BUILDING TYPE 300 | Slab Edge & 1st Floor Plan Composite

ROUND BARN VILLAGE

SANTA ROSA, CA

CURRENT EXISTING 2ND BUILDING DEPARTMENT SUBMITTAL SET

BUILDING TYPE 300 | Roof Plan

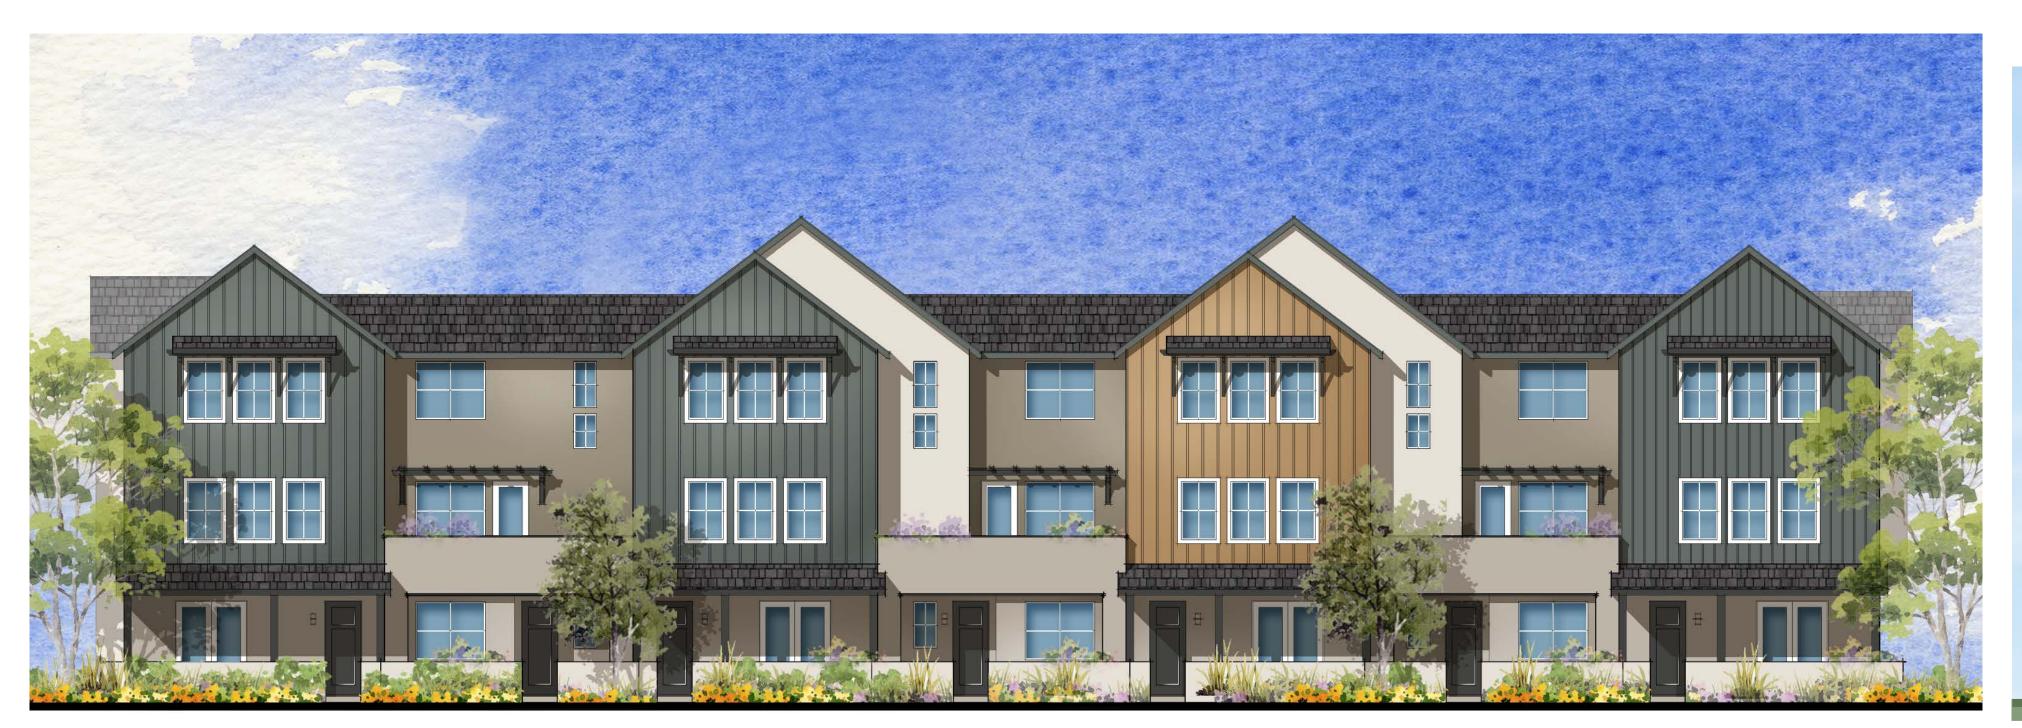
- 4 Added Gable/Sloped Roof
- **5** Removed Ladder
- **6** Revised Second Floor Massing at Kitchen
- 7 Added Awning
- **8** Added Trellis at Unit 2A, Typ.
- 9 Per City Fire Request The Rear Elevation Roof Design Has Been Modified

BUILDING TYPE 300 | Style 1 Exterior Elevations

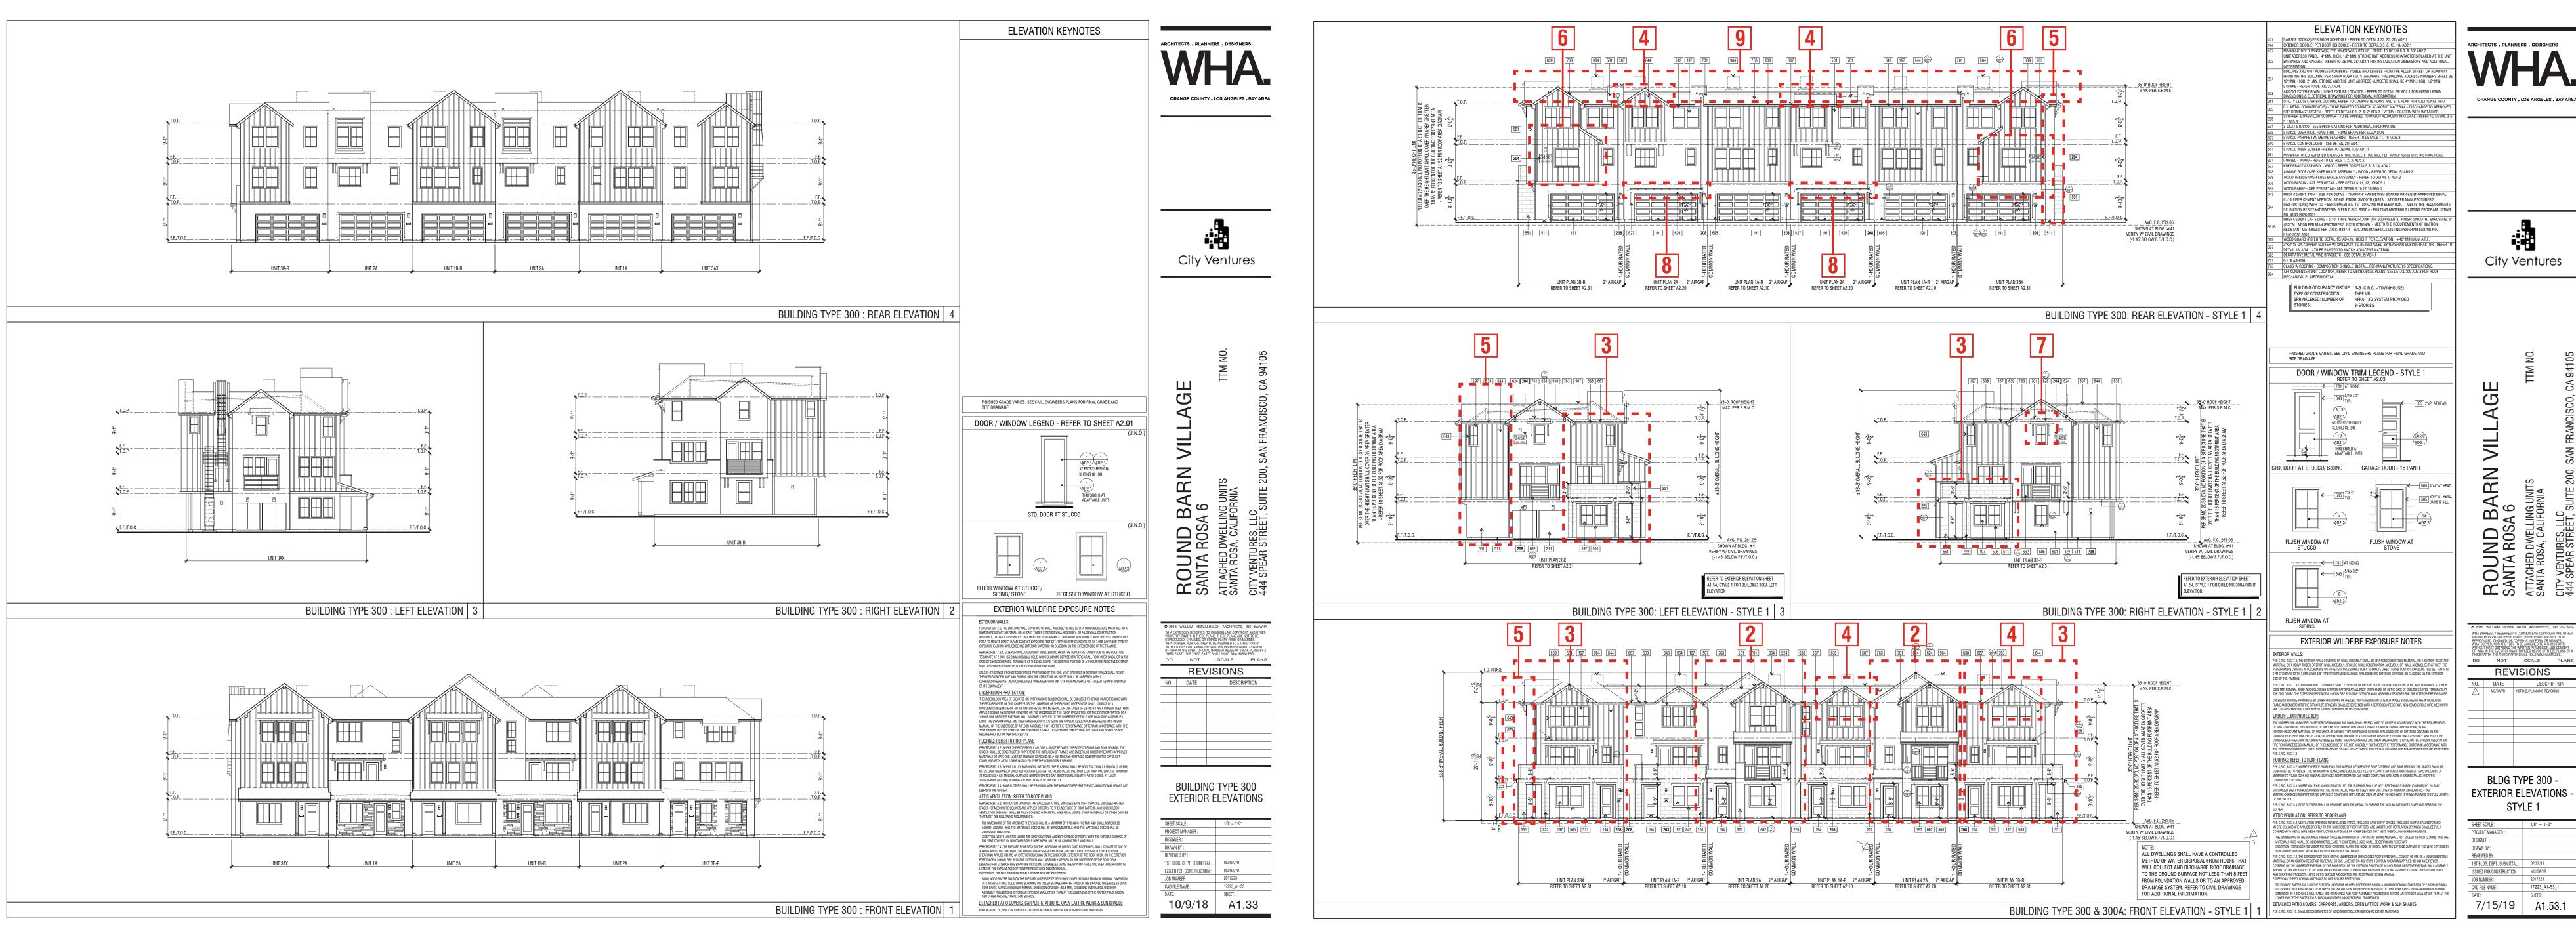
- 4 Added Gable/Sloped Roof
- 5 Removed Ladder
- **6** Revised Second Floor Massing at Kitchen
- 7 Added Awning
- **8** Added Trellis at Unit 2A, Typ.
- **9** Per City Fire Request The Rear Elevation Roof Design Has Been Modified

BUILDING TYPE 400 | Style 1 Exterior Elevations

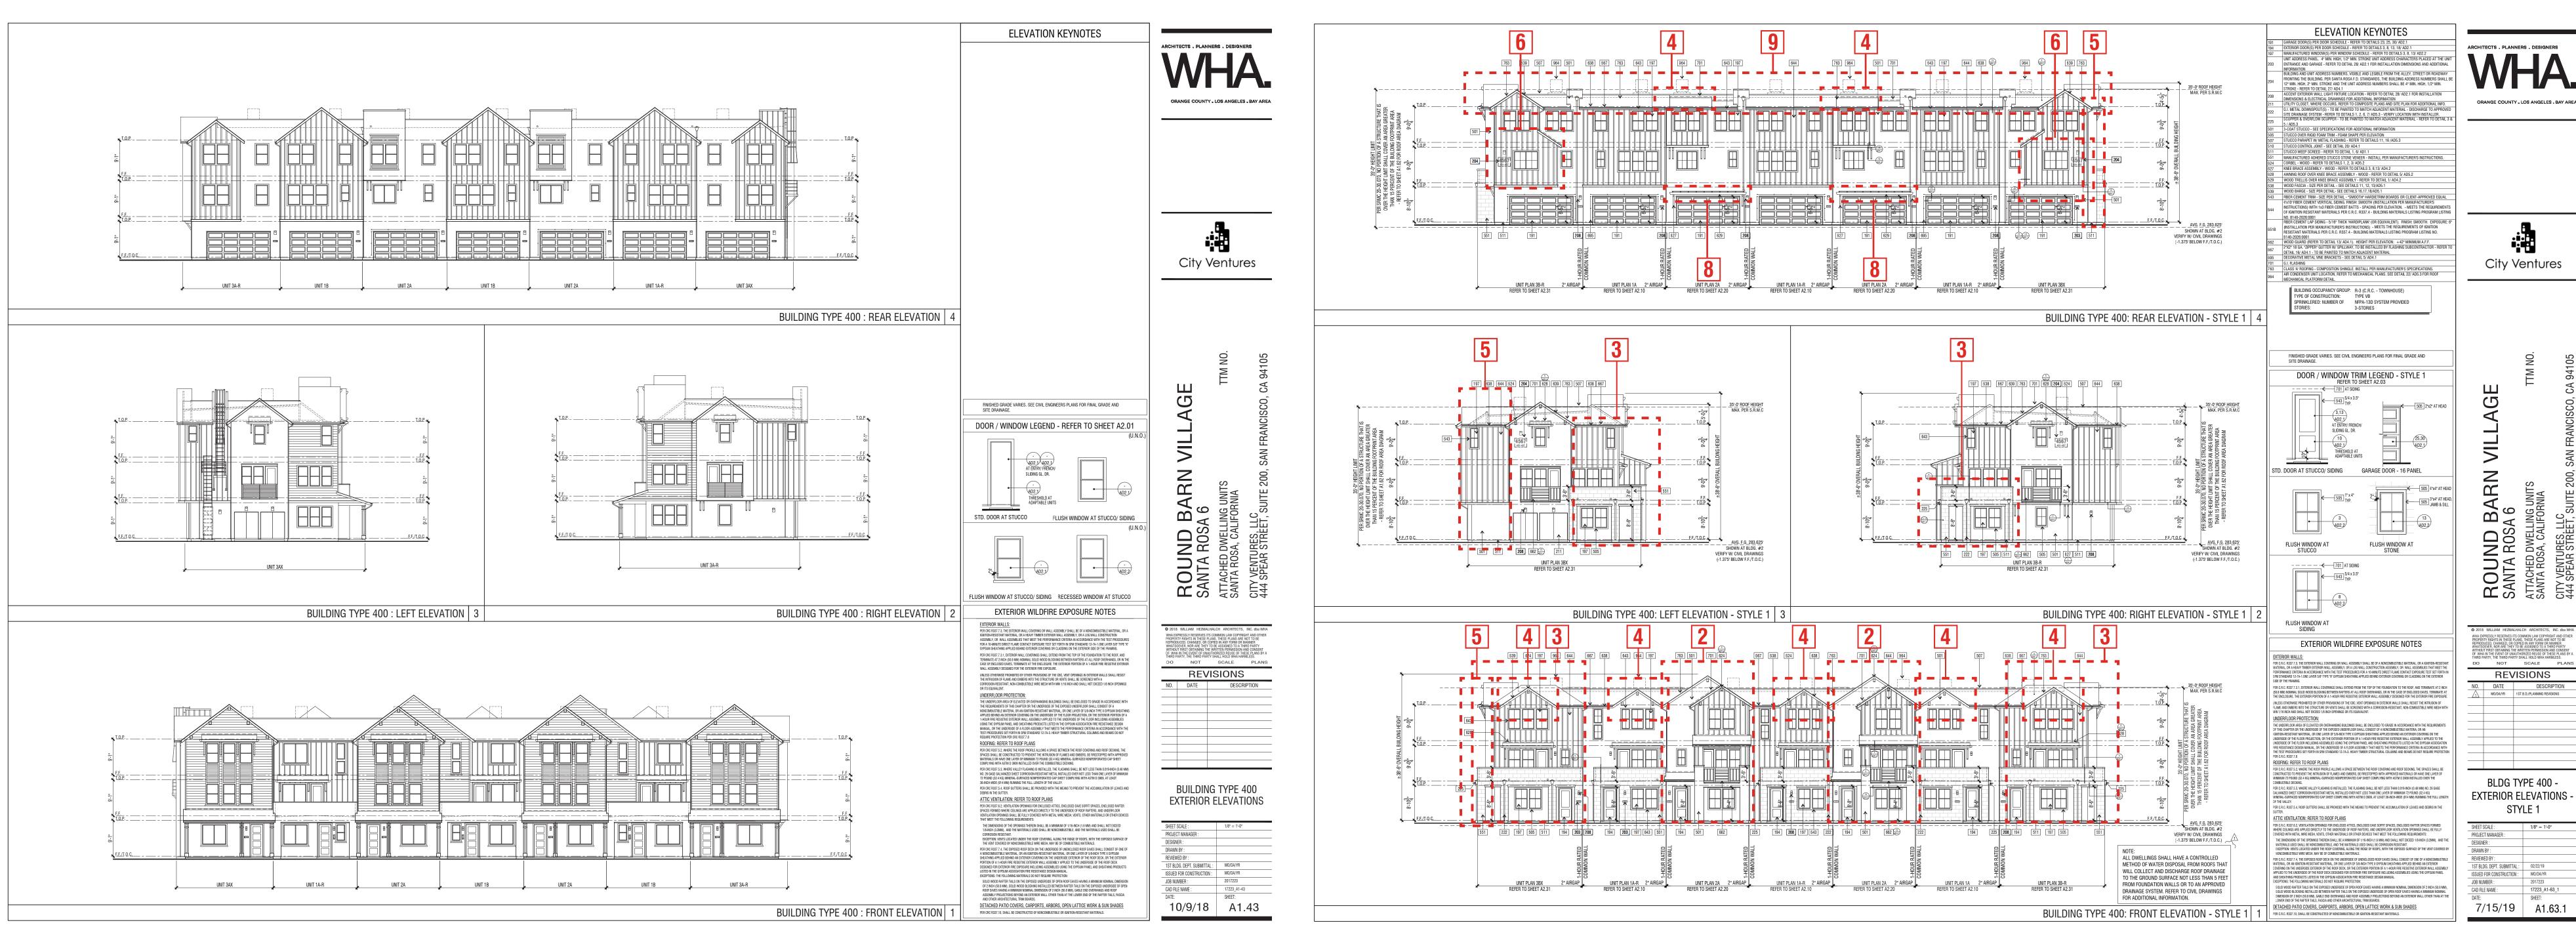
- 4 Added Gable/Sloped Roof
- 5 Removed Ladder
- 6 Revised Second Floor Massing at Kitchen
- 7 Added Awning
- **8** Added Trellis at Unit 2A, Typ.
- **9** Per City Fire Request The Rear Elevation Roof Design Has Been Modified
